DEVELOPMENT APPLICATION ASSESSMENT REPORT

Application Number:	DA2021/2569
----------------------------	-------------

Responsible Officer:	Kye Miles
Land to be developed (Address):	Lot 187 DP 16902, 19 The Outlook BILGOLA PLATEAU NSW 2107
Proposed Development:	Alterations and additions to a dwelling house including a swimming pool
Zoning:	C4 Environmental Living
Development Permissible:	Yes
Existing Use Rights:	No
Consent Authority:	Northern Beaches Council
Land and Environment Court Action:	No
Owner:	Gary Barber Cynthia Barber
Applicant:	Antony George Robb

Figure 1.

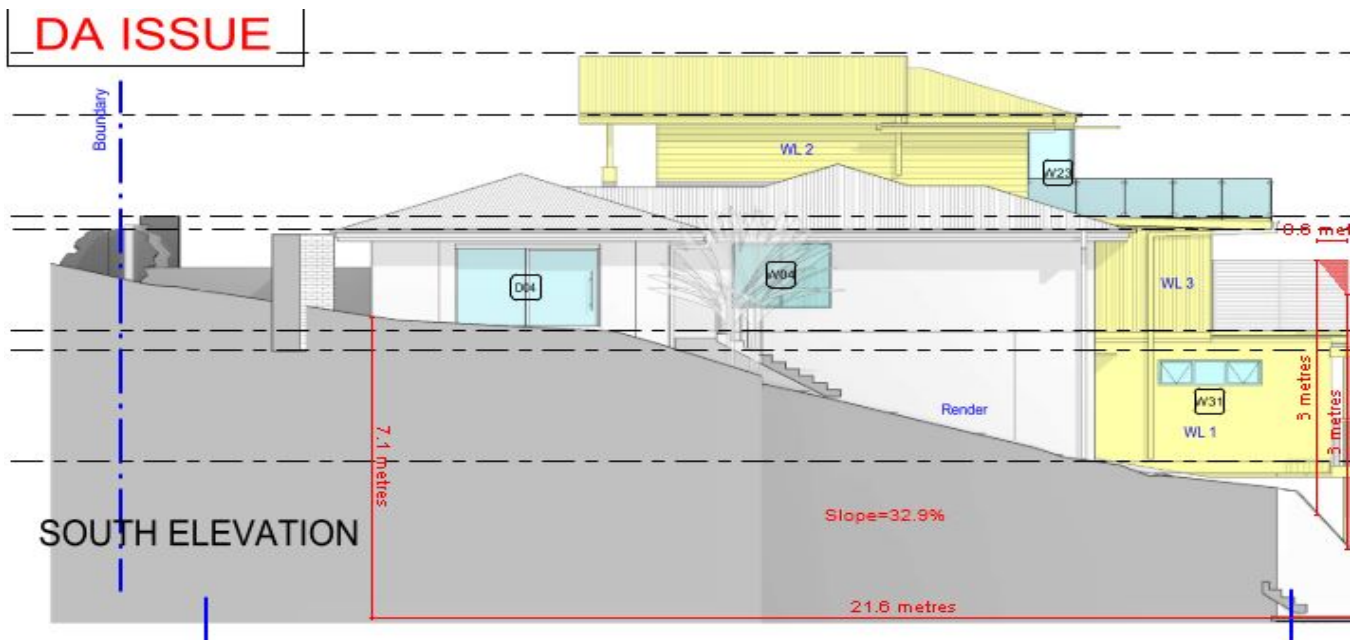
The proposed privacy screen located on the ground floor deck encroaches the southern side boundary envelope up to 0.8m for a length of 0.6m.

The extent of the non-compliance is shaded in red below within Figure 1.
